DEVELOPMENT REVIEW COMMITTEE (DRC) COMMENT REPORT

PROJECT NAME: Henderson Behavioral Health Crisis Stabilization Unit

CASE NUMBER: R18079

REQUEST: Site Plan Level III Review: Conditional Use for Social Service Residential Facility (SSRF) Level IV with Flex Allocation and Associated Parking Reduction

Existing Stormwater Asset Map possibly affected by the Proposed Development

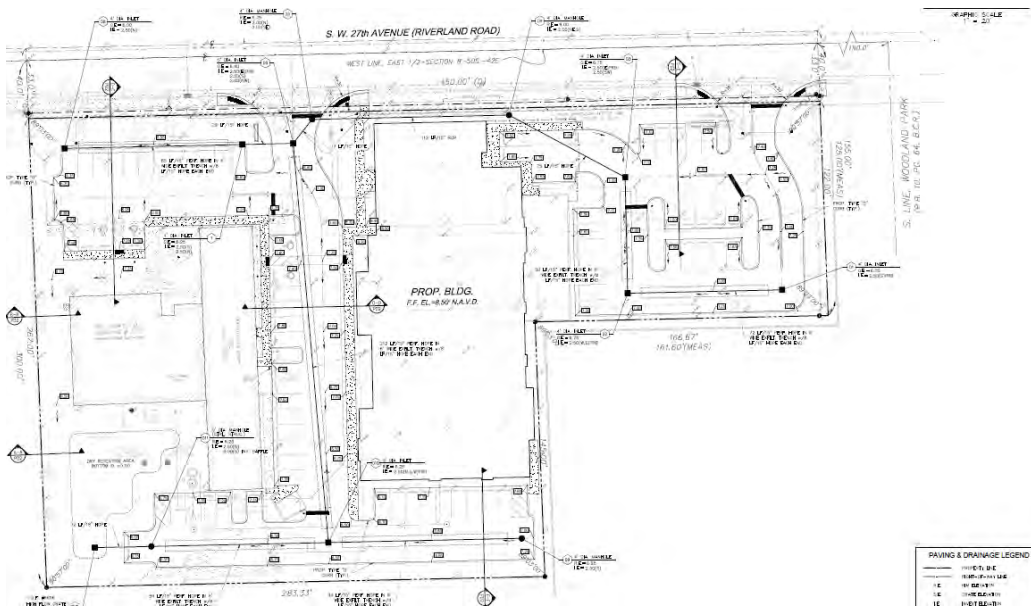
1. Please provide (or revise if already submitted) an erosion, sedimentation, and stormwater pollution prevention plan (**SWPPP**) showing the adjacent City's existing stormwater system as shown in the survey and to the limits shown with green line work in the storm map provided at the end of this report. A copy of the approved SWPP shall be at the construction site from the date of demolition initiation to the date of final construction activities.

2. Please prepare and submit a separate utility demolition plan for review of impact to existing City's stormwater systems.
